RE: AMENDED DEVELOPMENT ORDER FOR "THE SHORES OF CRYSTAL BEACH"
ALSO KNOWN AS "CRYSTAL SHORES" - A 13-LOT SINGLE FAMILY DETACHED
PLANNED UNIT DEVELOPMENT AND MAJOR DEVELOPMENT LOCATED SOUTH OF OLD
HIGHWAY 98 BETWEEN CRYSTAL BEACH DRIVE AND HUTCHINSON STREET

REPORT AND RECOMMENDATION

STAFF REPORT

A PLANNED UNIT DEVELOPMENT AND A MAJOR DEVELOPMENT

TYPICAL LOT SCHEMATIC

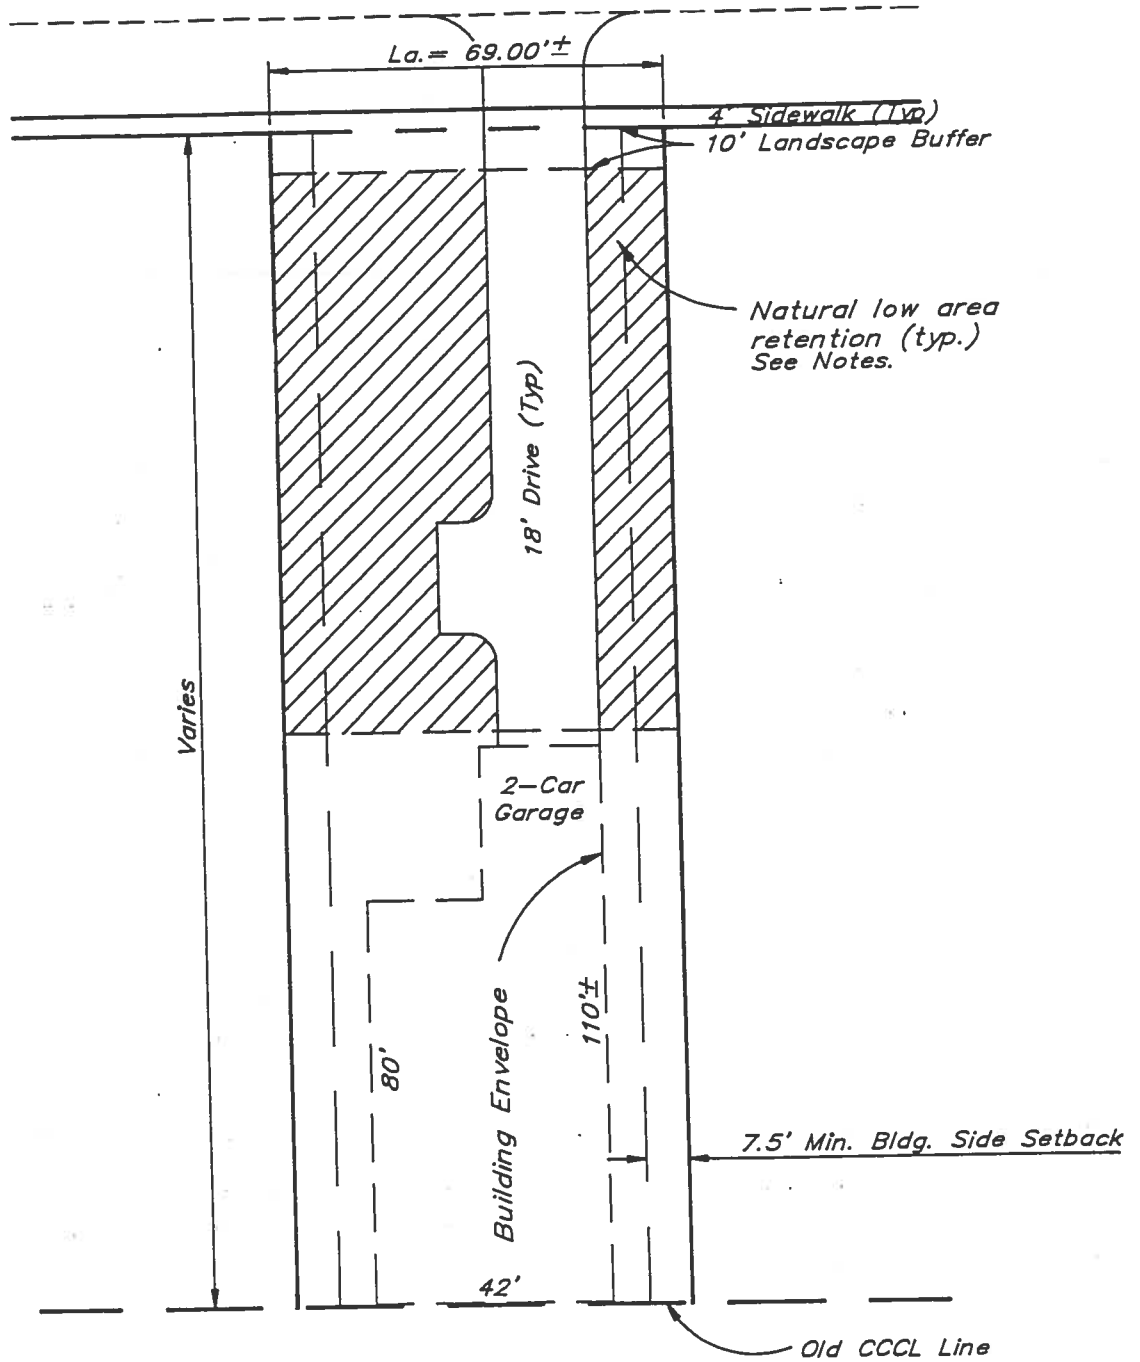
Access to the project is from Scenic Highway 98. Staff would have preferred that the project have an internal driveway off Highway 98 to access the individual units. However, because the CCCL was re-located so close to the highway in this area it did not appear feasible that DNR would encourage additional asphalt within the site. As a compromise, the developer has included a typical turn around area for each site which would allow each unit owner to enter the highway without backing into it. It is staff's recommendation that this be a part of the approved development.

The drawings submitted indicated a typical side setback of 7 1/2 ft. which would allow for 15' between buildings. However, DNR is enforcing its 40-60% ratio which would allow for a building footprint of approximately 41.5 to 42. feet. Limiting the footprint to 42' will increase the distance between buildings substantially. The typical front setback far exceeds the 20' required.

Reforestation <u>96</u>	Perimeter <u>36</u>	Parking Lot <u>n/a</u>
(10 per acre)	(1 tree per 25')	
Protected Trees on Site (12" to 23" diameter)	:	<u>none</u>
Preserved Trees on Site (24" or more diameter)	:	<u>none</u>
Credits for Protected/Preserved Trees	:	<u>none</u>
TOTAL TREES REQUIRED	:	<u>132</u>
TOTAL TREES PROVIDED	:	<u>**</u>

**applicant had misfigured trees/open space requirement. The above represents minimum requirement to be met.

2. As noted on the Mylar, a typical turn around area is to be provided for each lot to allow unit owners to enter the highway without backing into it.
3. The Department of Natural Resources Permit is required before the issuance of any building permits.

4. Ten (10) trees are required on each lot as noted on the Mylar.
5. All of the requirements as outlined on the attached Staff Report.
6. If the development is initiated within a one-year period your concurrency status is protected for five years through August 2, 1997.
